## **Agenda item 4.1 (b)**

# Revision of AM0118: Introduction of low resistivity wire or cable to new or existing power line

**CDM EB 97**

### Other issue: +/-20% variation mechanical characteristics

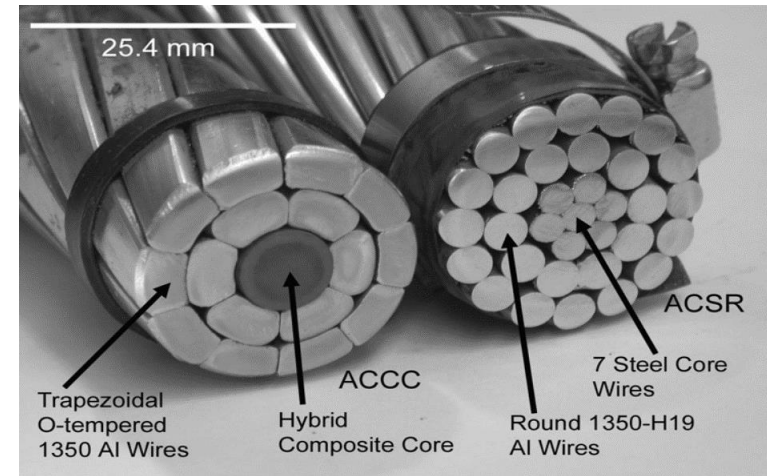
- **Current Text:** The PJ transmission line possesses the same or equivalent mechanical characteristics of no more than **+/- 20 %** as compared to BL line
- **Proposal:**
  - Retain the requirement.
- **Rationale:**
  - not possible to have same diameter and conductor cross sections in both (baseline and project cases)
    - Different standards apply for ACCC (PJ) and ACSR (BL): ACSR IEC 61089, for ACCC ASTM B987 / B987M – 17)
